Access Compliance Report

Public Rights-of-Way

Intersection ID: 17548	Main Street: ROSWELL_AV	Cross Street: STERLING_RD	Location: SW
ADA ID: 14916A8DC13A	Ramp Type: PerpDiag	Initial Pass/Fail: Fail	Overall Compliance: No
			Severity Score: 26.25

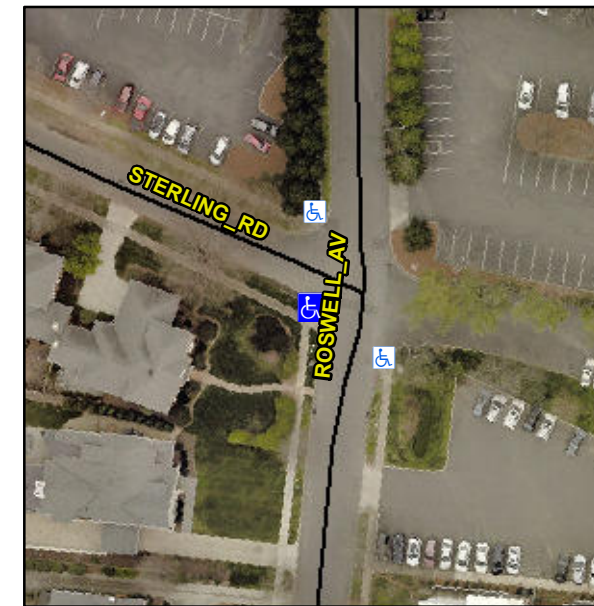
Not Found, R304.2.2, R304.5.3

Compliance	Description	Data	Compliance	Description	Data
N/A	Ramp Length (in)	63.0	No	Ramp Slope (%)	12.5
Yes	Ramp Width (in)	48.0	No	Ramp XSlope (%)	3.2
N/A	Flare Type LT	N/A	N/A	Flare Type RT	N/A
N/A	Flare Slope LT (%)	N/A	N/A	Flare Slope RT (%)	N/A
N/A	Flare Traversable LT?	N/A	N/A	Flare Traversable RT?	N/A
N/A	Landing Length (in)	N/A	N/A	DWS Provided?	N/A
N/A	Landing Width (in)	N/A	N/A	DWS Contrast?	N/A
N/A	Landing Slope (%)	N/A	N/A	DWS Length (in)	N/A
N/A	Landing X Slope (%)	N/A	N/A	DWS Full Width?	N/A
N/A	Landing Curb? (Y/N)	N/A	N/A	DWS Offset (in)	N/A
N/A	Shared Landing?	N/A			
N/A	Gutter Ponding?	N/A	N/A	Gutter Slope (%)	N/A
N/A	Gutter Lip Ht (in)	N/A	N/A	Gutter X Slope (%)	N/A
N/A	Painted X Walk1?	No	N/A	Painted X Walk2?	No
	X Walk 1 Direction	To SE		X Walk 2 Direction	To N
N/A	X Walk 1 Width (in)	N/A	N/A	X Walk 2 Width (in)	N/A
	X Walk 1 Slope (%)	3.7		X Walk 2 Slope (%)	0.1
	X Walk 1 X Slope (%)	0.1		X Walk 2 X Slope (%)	5.1

Remove & Replace Curb Ramp With Two New Directional Ramps or Equivalent.
